Before the Taranaki VTM Expert Panel

in the matter of: an application by Trans-Tasman Resources Limited for marine consents to support a seabed mining operation in the South Taranaki Bight

Statement of evidence of **Regan James King** (Offshore Geotechnical) for Taranaki Offshore Partnership

Dated: 3 October 2025

Figure 2: Surficial geological map of the Proposal area (NIWA, 2015).

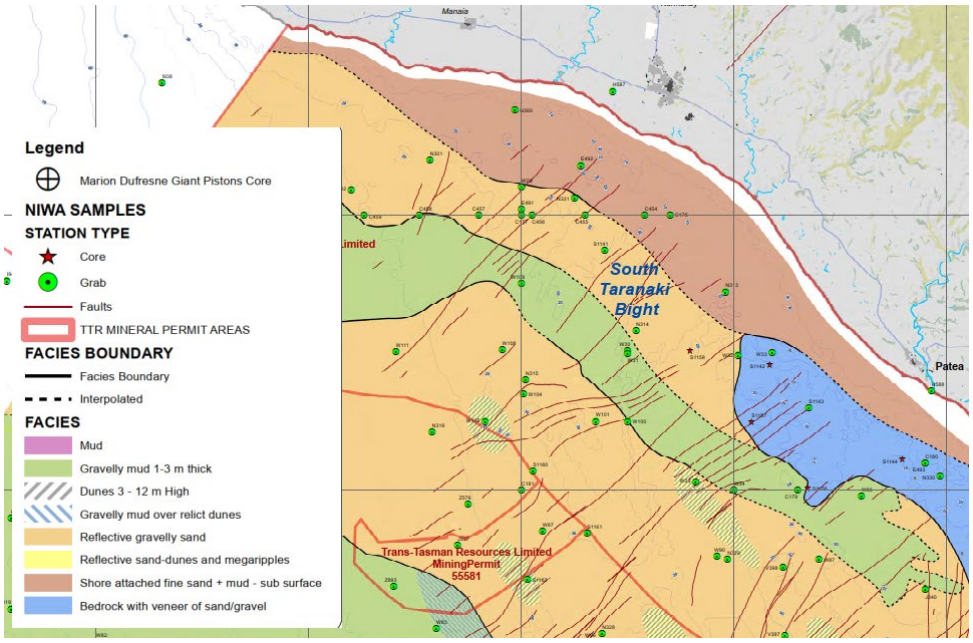
20 The Proposal site is identified in **Figure 2** below and comprises part of TTRL's wider Mining Permit MP55581. Figure 2 is taken from the Geological Desktop Summary provided with the Application[3] and illustrates the surficial geological units that have been identified in the Proposal area. The units include gravelly sand, sand-dunes and megaripples (dunes 3-12 m high), gravelly mud 1-3 m thick, gravelly mud over relict dunes, and various faults. It is unclear from the Geological Desktop Summary what the geological unit depths and thicknesses are.

21 In my opinion, TTRL's application does not contain sufficiently detailed information on either:

21.1 the current/baseline geotechnical properties of the seabed in the Proposal area; or

21.2 the geotechnical properties of the re-deposited material;

to assess the geotechnical effects of the Proposal.
